Appendix I Proposed Building Design Changes

Appendix II Perspective Showing Current and Proposed Building Massing

Urban Village Phase 3

APPENDIX II

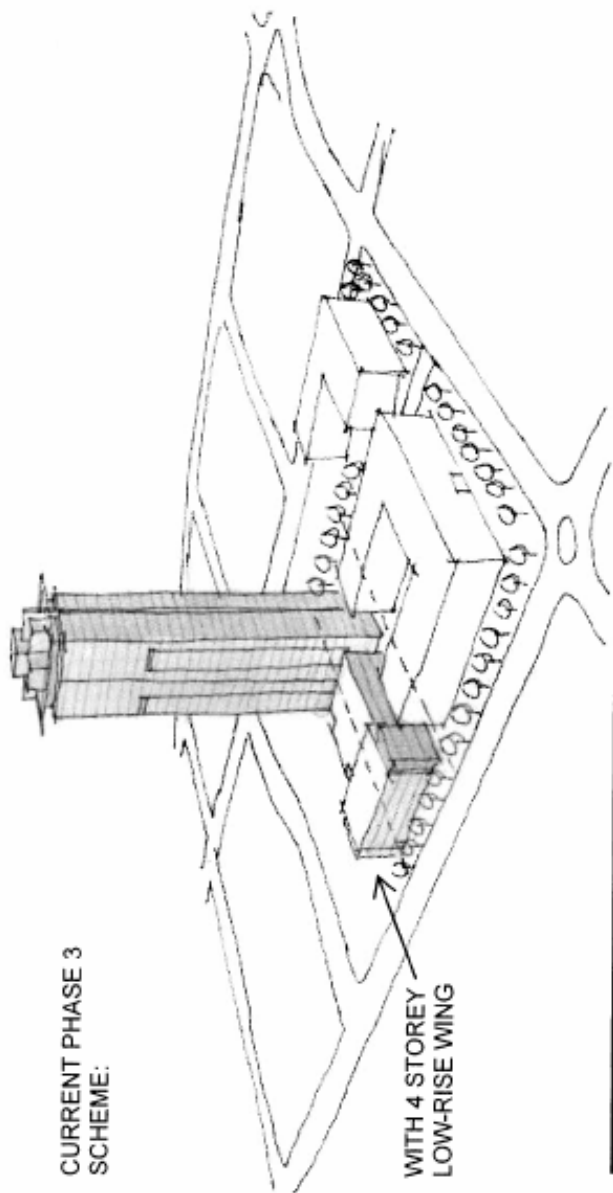
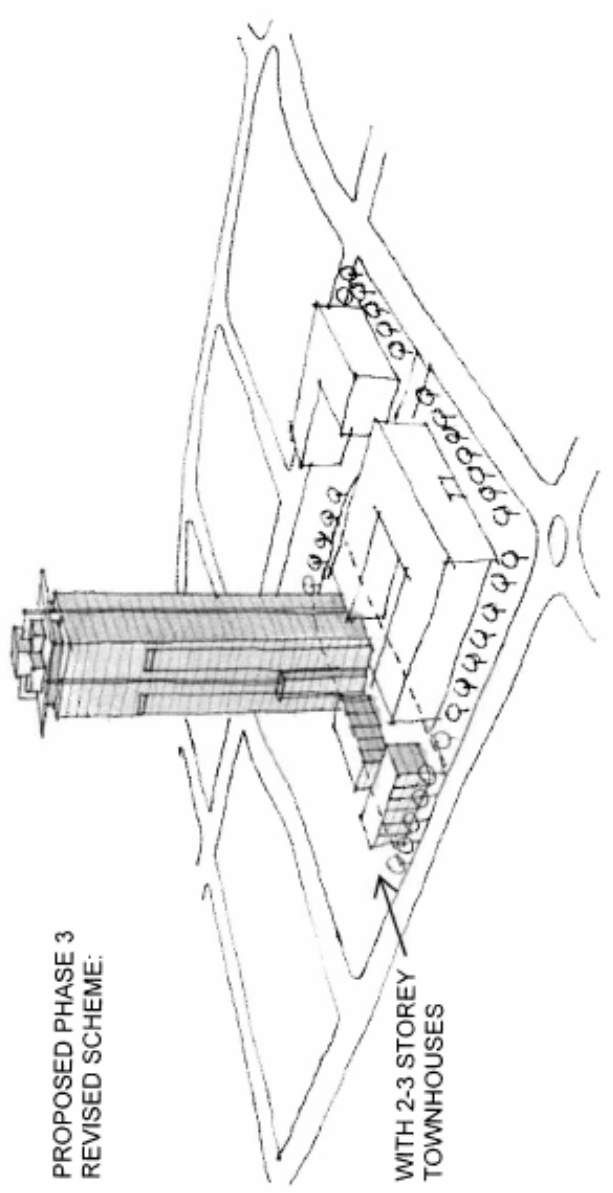
The developer is proposing to eliminate the 4-storey wood-frame portion of the building and is proposing instead to construct 11, 2-storey townhouse units with rooftop terraces. The townhouse units will be located along 133 Street to continue the street facade proposed with the original scheme, and along the north side of the lot adjacent to the 8-metre (26-foot) wide walkway that runs east-west through the Weststone project site. The location of the townhouses along the west and north perimeter of the site, coupled with the high-rise tower on the east side of the site, creates an enclosed outdoor amenity area that mirrors the outdoor amenity space of the Weststone Phase 1 building located on the adjoining property to the south.

The proposed 36-storey tower on the east side of the subject site remains unchanged in terms of building footprint and height. However, the developer is proposing to amend the internal layout of the building by adding studio units on floors two to nine, which, as the units extend out from the exterior walls of the building, will result in greater articulation and interest to the building facade (see Appendix II).

CURRENT PHASE 3 SCHEME:

WITH 4 STOREY LOW-RISE WING

PROPOSED PHASE 3 REVISED SCHEME:

WITH 2-3 STOREY TOWNHOUSES
